O'REILLY ADDITION

Re: S/D 96-61 O'REILLY ADDITION (Final Plat)

Re: S/D 96-61 O'REILLY ADDITION (Final Plat)

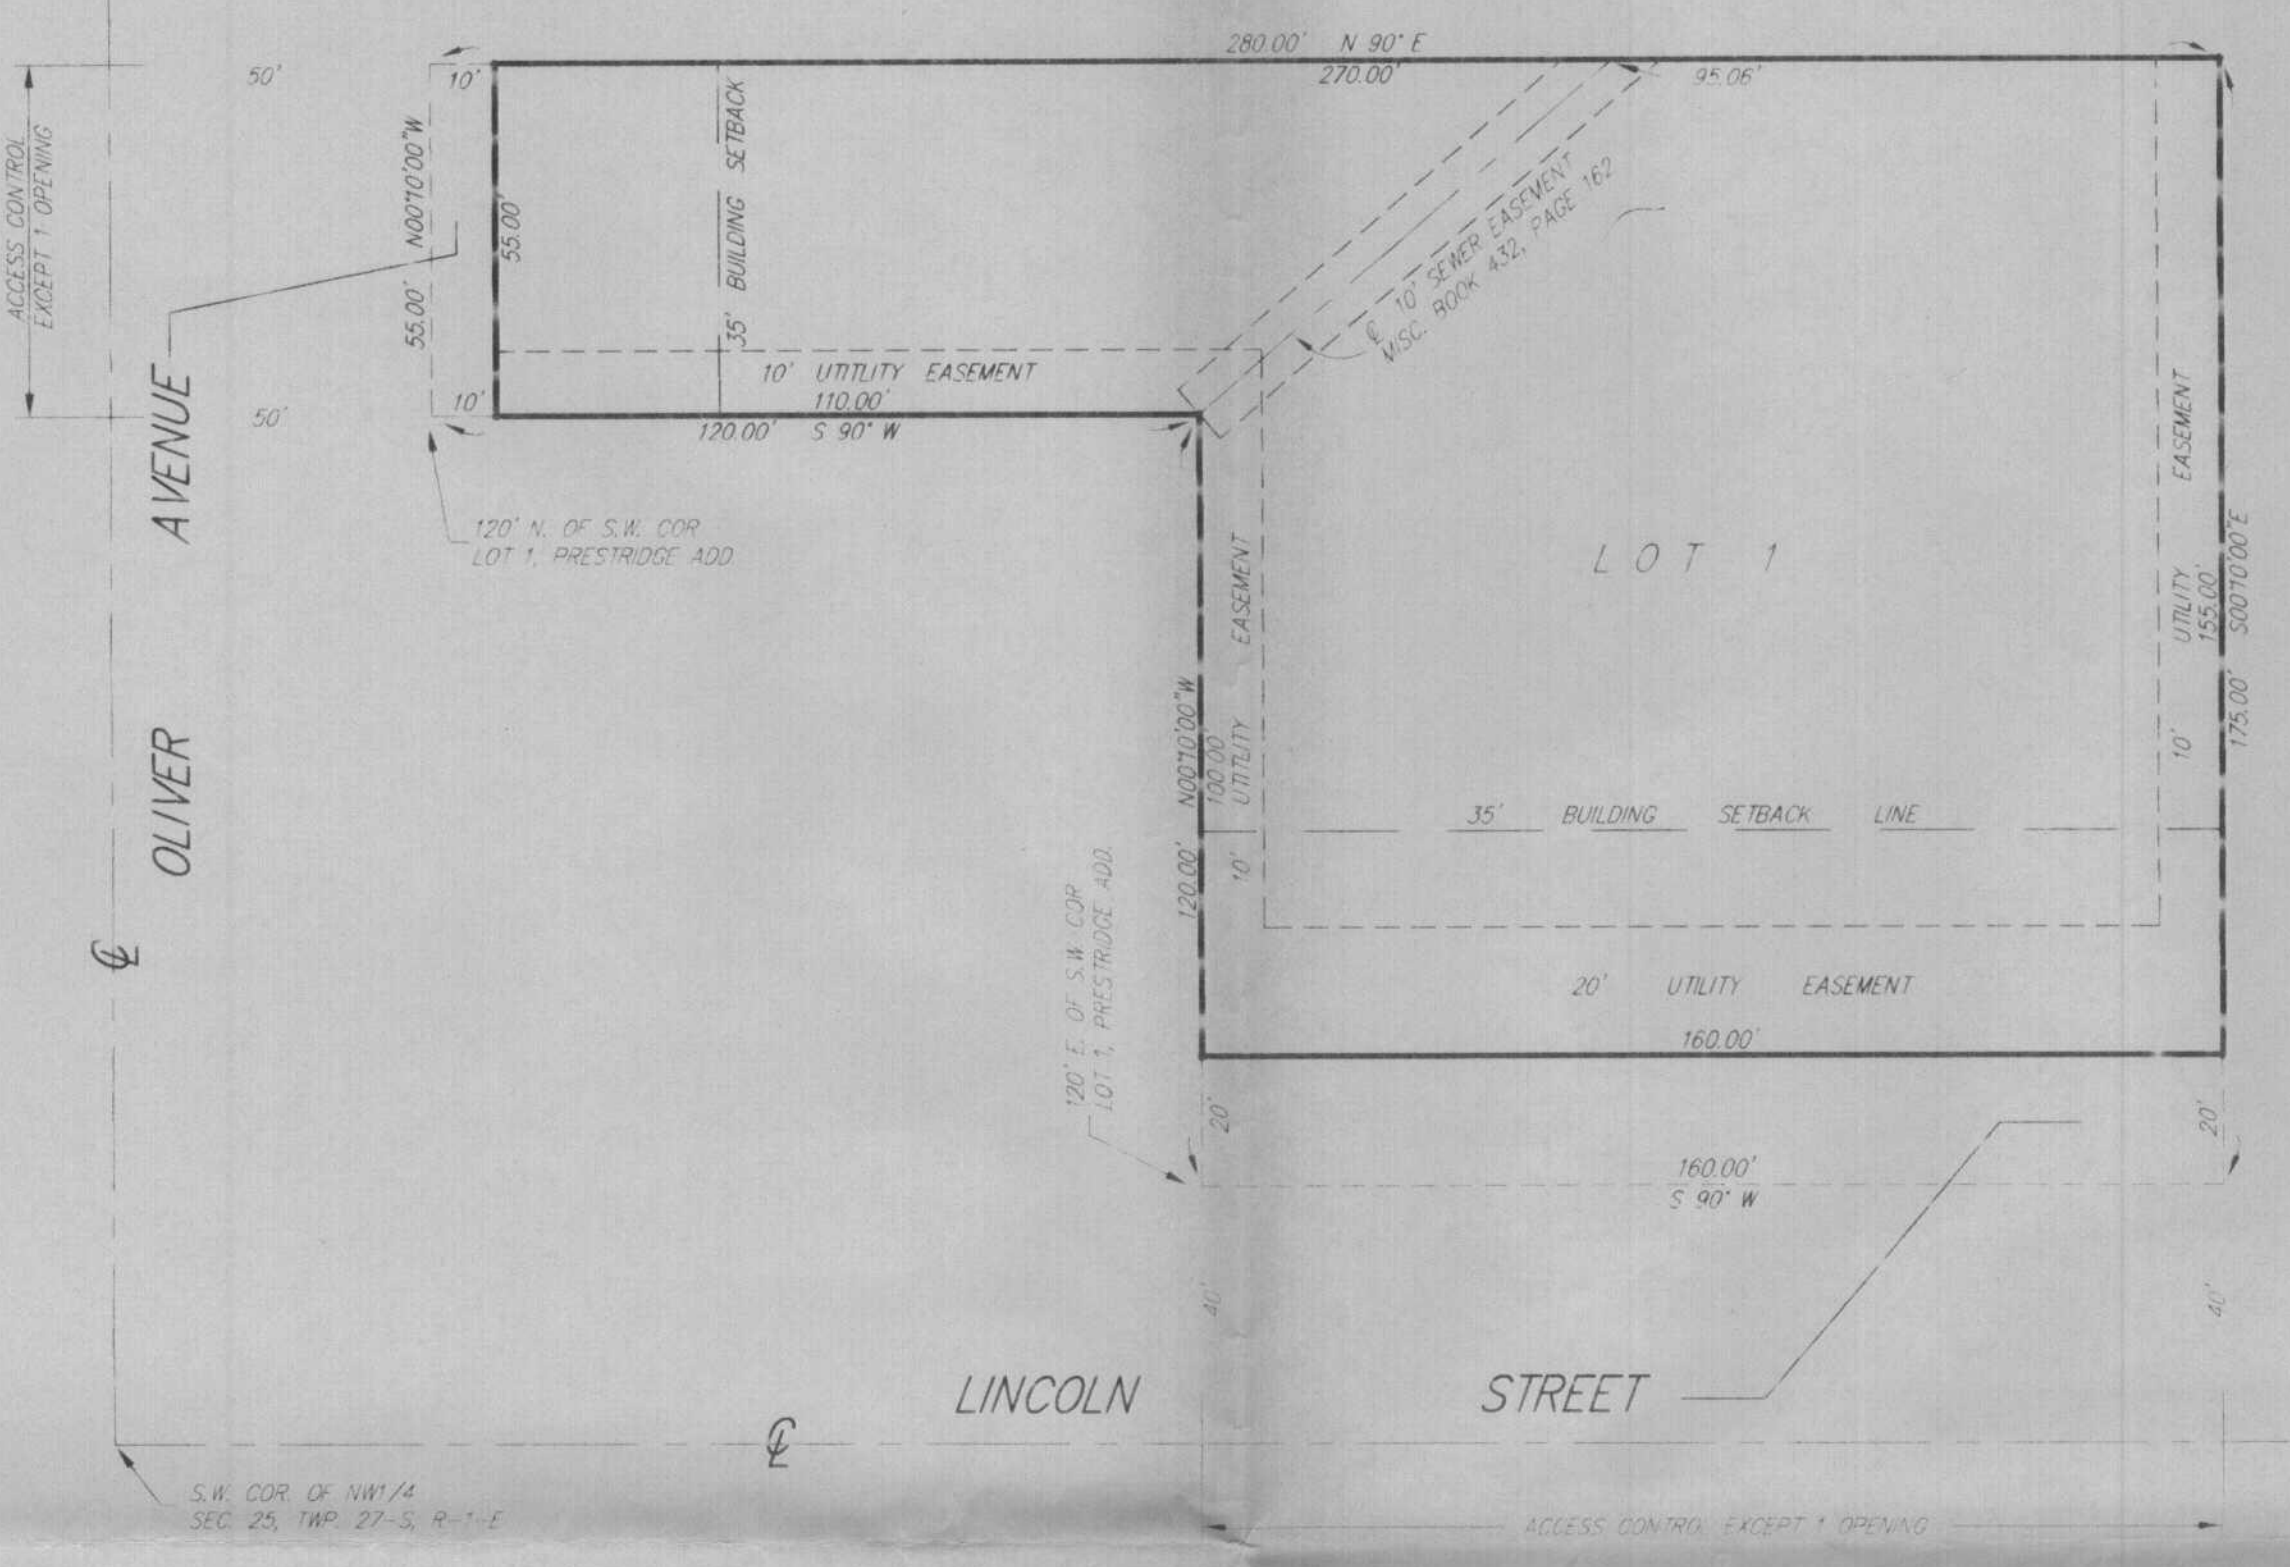
- ~~A.~~ The applicant shall guarantee any drainage improvements required by the platting of this property.
- ~~B.~~ *Approved along S line of plat*
An existing use (building) at the corner of Oliver and Lincoln is being surrounded by this plat. Sanitary sewer service is apparently being provided by a service line crossing abutting properties and covered by a ten (10) foot utility easement. A 20-foot public easement shall be provided at some location to allow for extension of a public sewer line to that site.

- ~~C.~~ Access control except for one opening shall be granted along Lincoln from this plat.
- ~~D.~~ Additional street right-of-way shall be dedicated rather than contingently dedicated.

- ~~E.~~ The applicant shall install or guarantee the installation of all utilities and facilities which are applicable and described in Article 8 of the MAPC Subdivision Regulations. (Water service and fire hydrants required by Article 8 for fire protection shall be as per the direction and approval of the Chief of the Fire Department.)

- ~~F.~~ The applicant's engineer is advised that the Register of Deeds is requiring the name(s) of the notary public, who acknowledges the signatures on this plat, to be printed beneath the notary's signature.

- ~~G.~~ Perimeter closure computations shall be submitted with the final plat tracing. Section 5-101(c).

- H. Recording of the plat within 30 days after approval by the City Council and/or County Commission.
- I. In accordance with Section 16.04.040 - Permit Fees Item 2a,b (Ord. 42-583) and Section 17.12.065 - payment for connection to water system for properties not included in benefit districts (Ord. 42-584), this property may or may not have been included in a benefit district. The applicant/agent should contact Betty Roark, with OCI at 268-4341 and Chuck Steven, Water & Sewer at 268-4555, to determine whether assessments are due.
- J. The applicant's drainage plan is approved.
